June 17, 2020

Re: Comment Response Letter:
Response and Development Work Plan (Rev. 1)
Area B: Sub-Parcel B6-3
Tradepoint Atlantic
Sparrows Point, MD 21219

RESPONSE AND DEVELOPMENT WORK PLAN

AREA B: SUB-PARCEL B6-3
TRADEPOINT ATLANTIC
SPARROWS POINT, MARYLAND

SHEET TITLE:
OVERALL SITE PLAN
SHEET NUMBER:
C-301
ORG. DATE - 4/17/2020

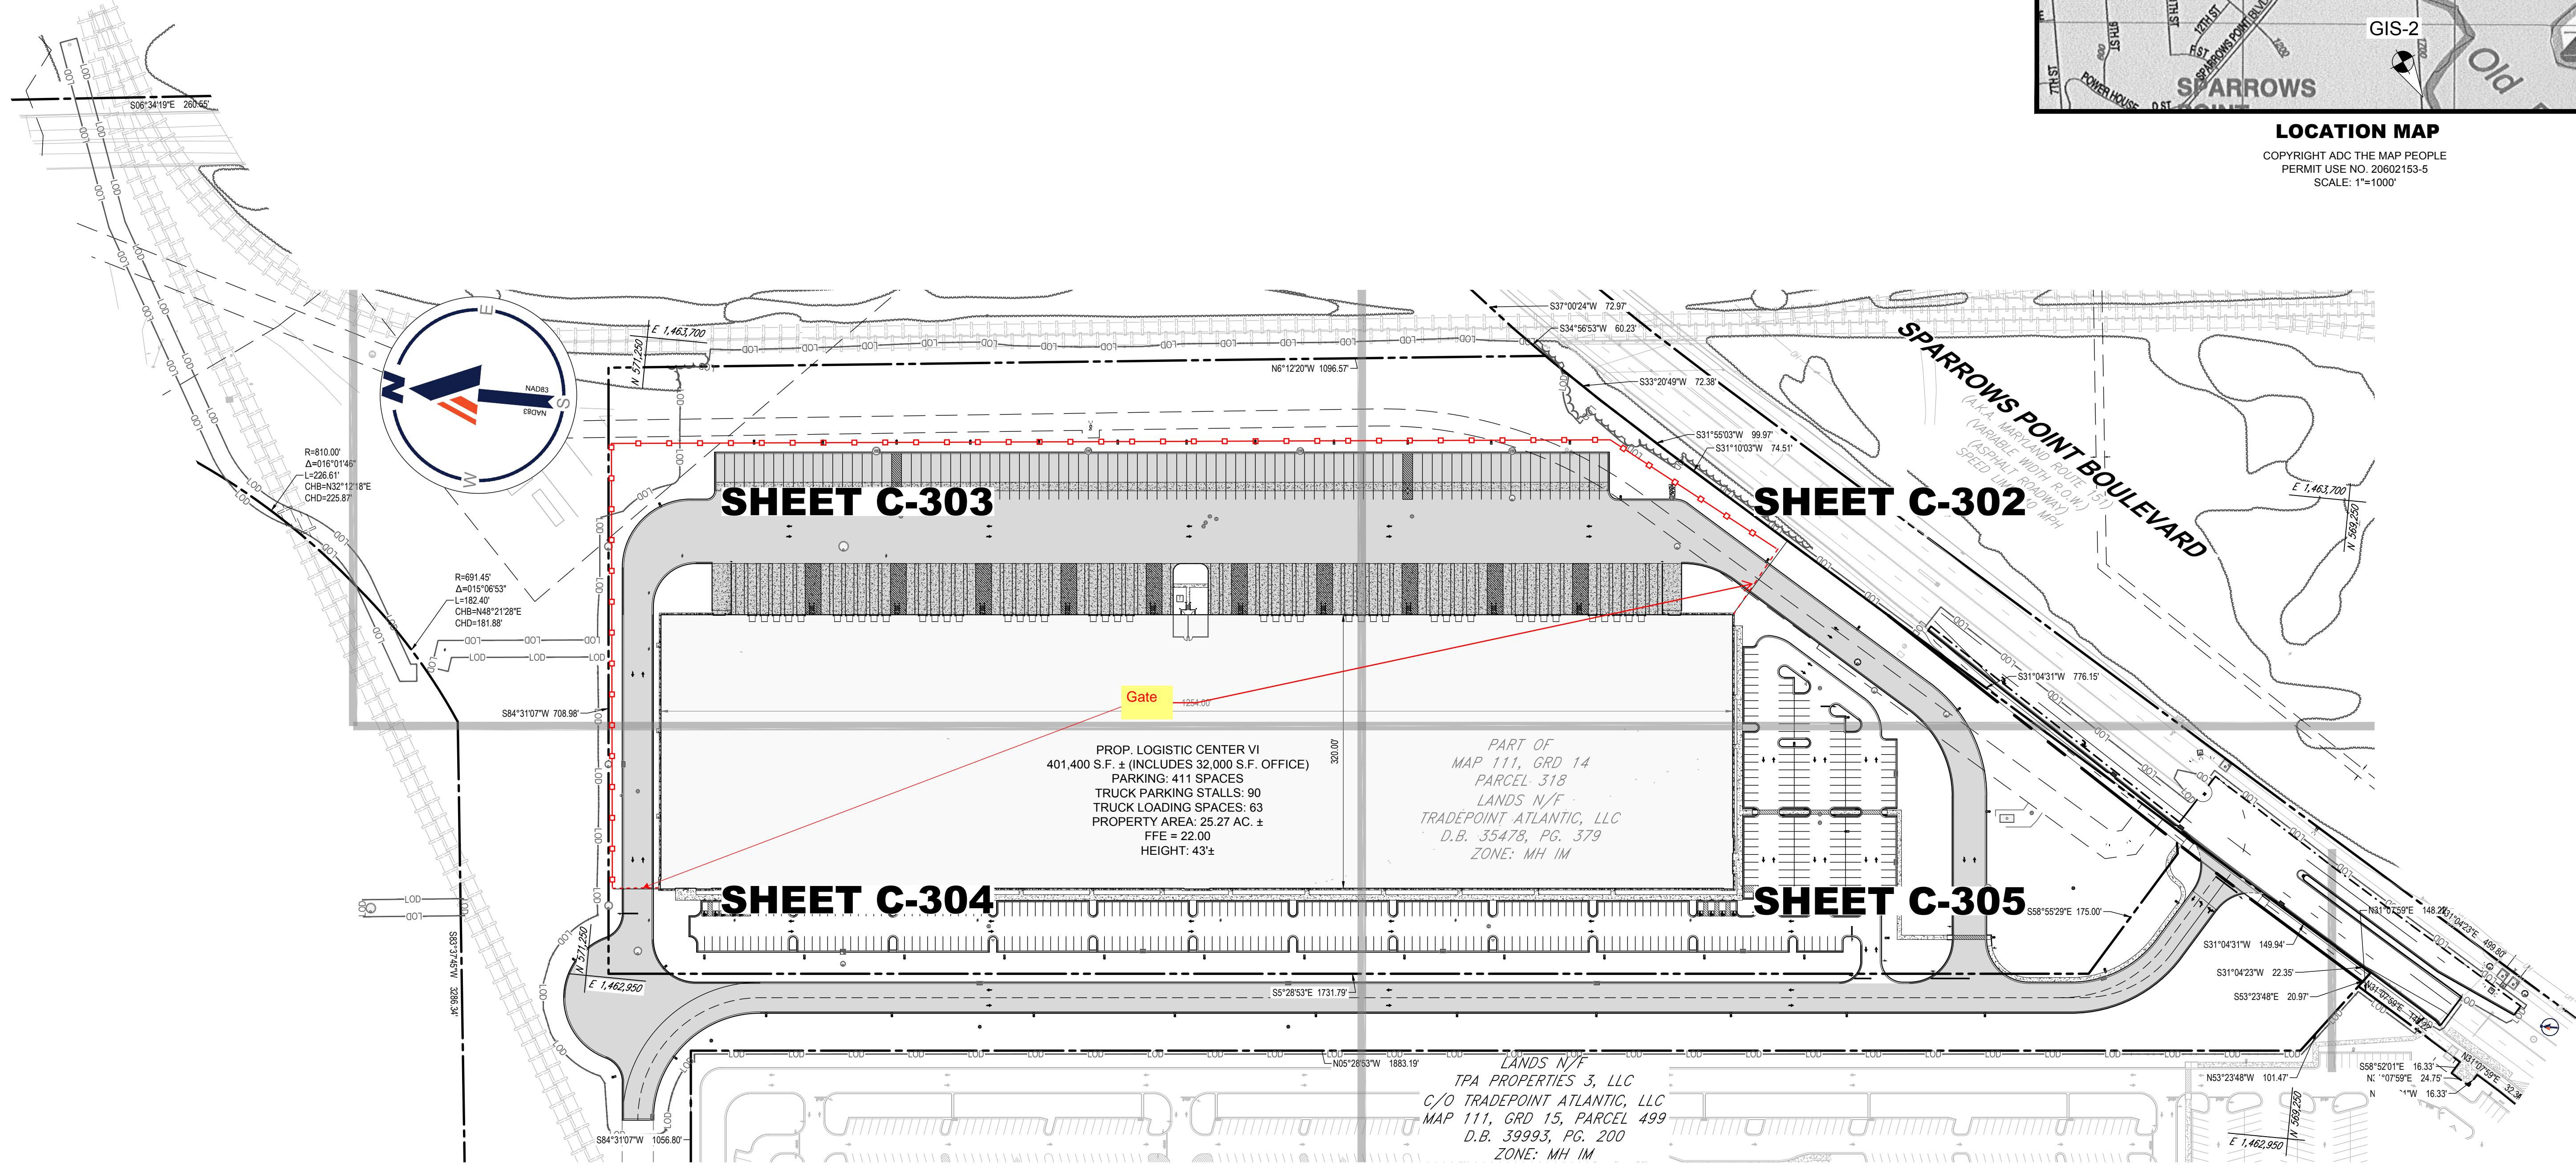
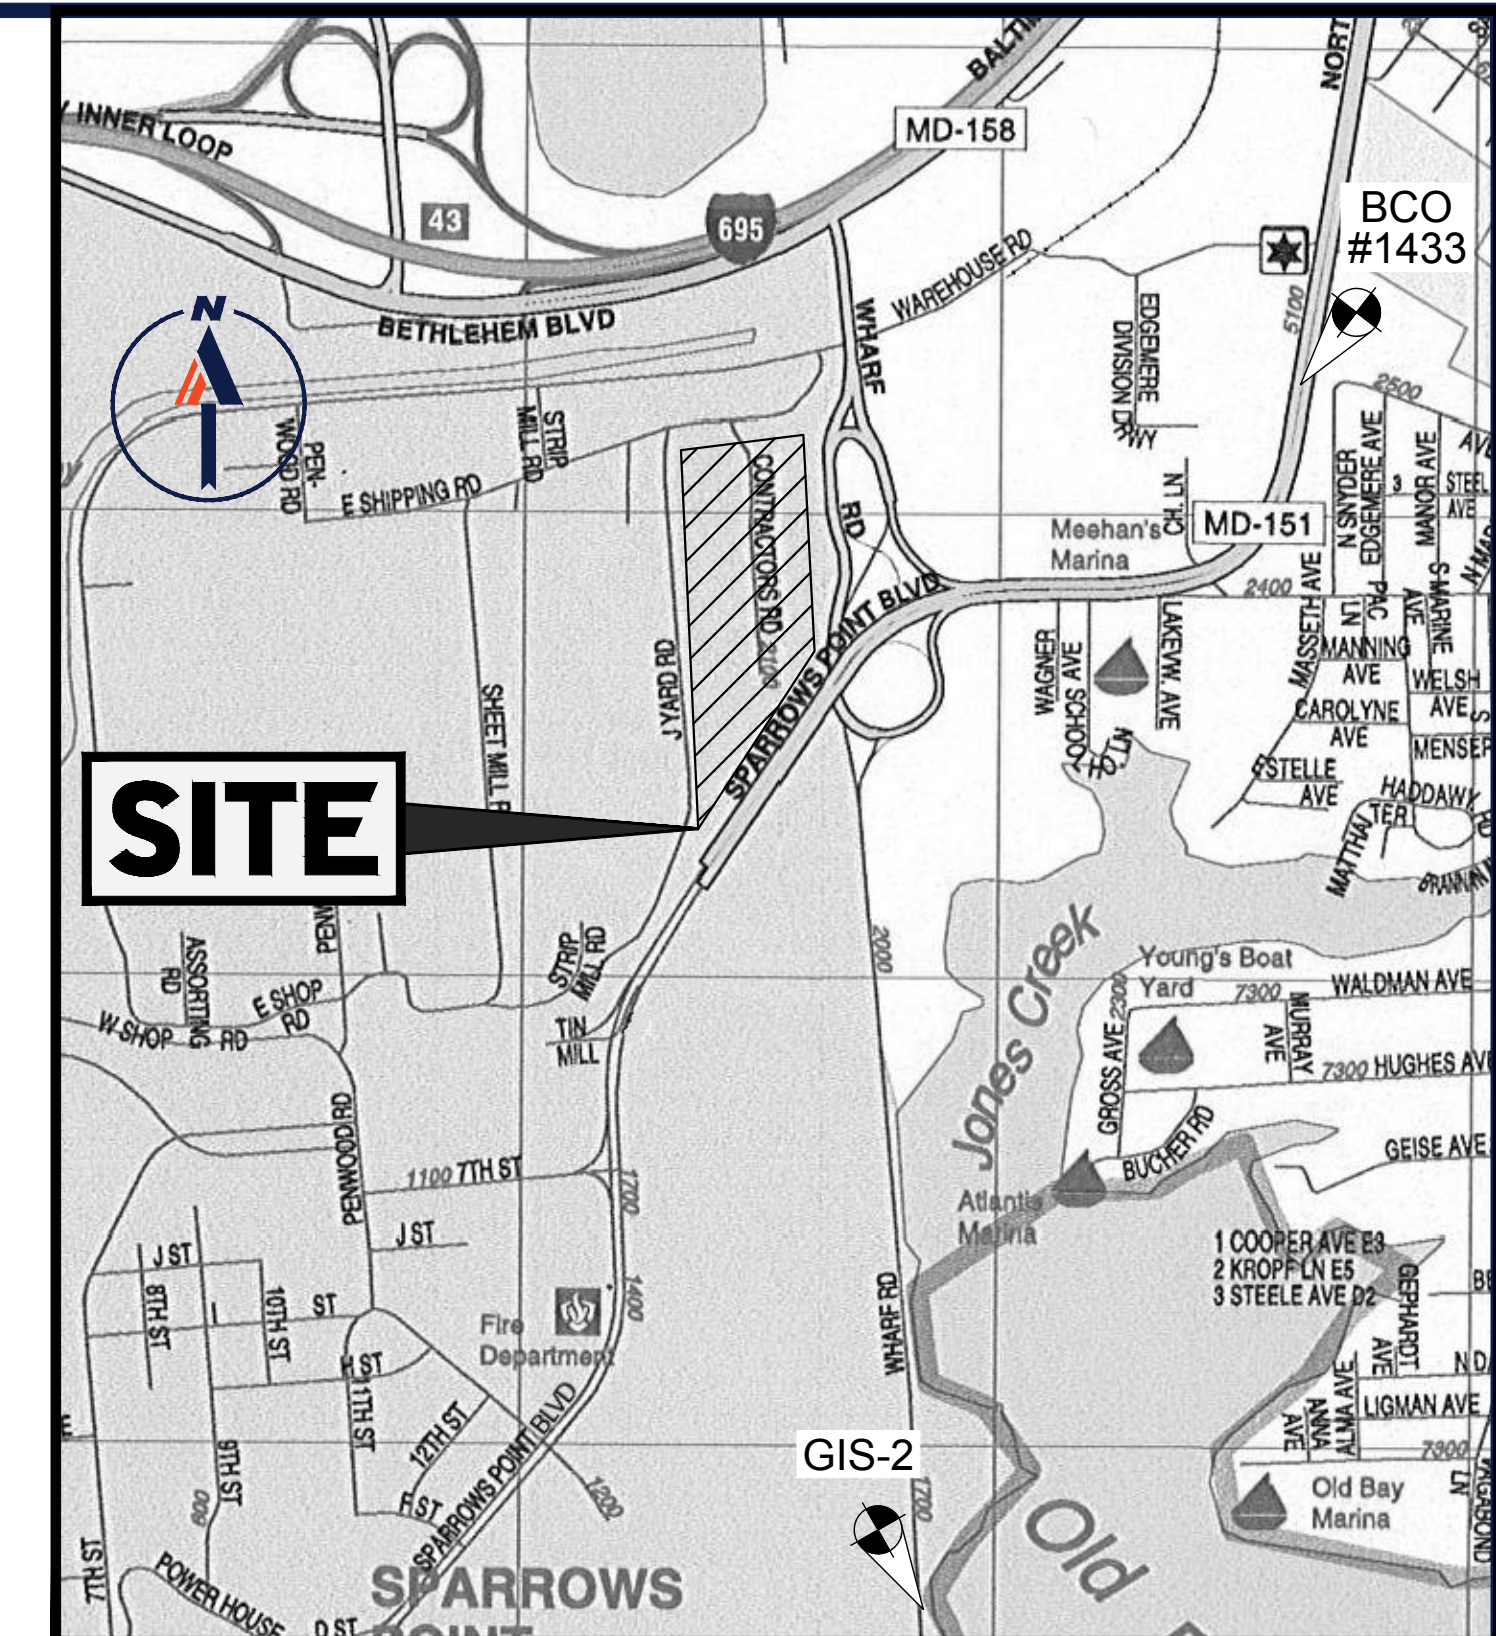
2. *Please provide a figure showing the location of permanent fencing around this development parcel, if planned.*

3. *Will the entrance to this facility off Sparrows Point Boulevard be gated?*

Appendix D has been updated to include a new drawing that shows the location of permanent fencing. There will be fencing around the east and north sides of the Site.

The new drawing included in **Appendix D** (attached to this letter) shows that gates will provide secure access to the fenced area on the north and east sides of the Site. The parking lot located off Sparrows Point Boulevard will not be gated.
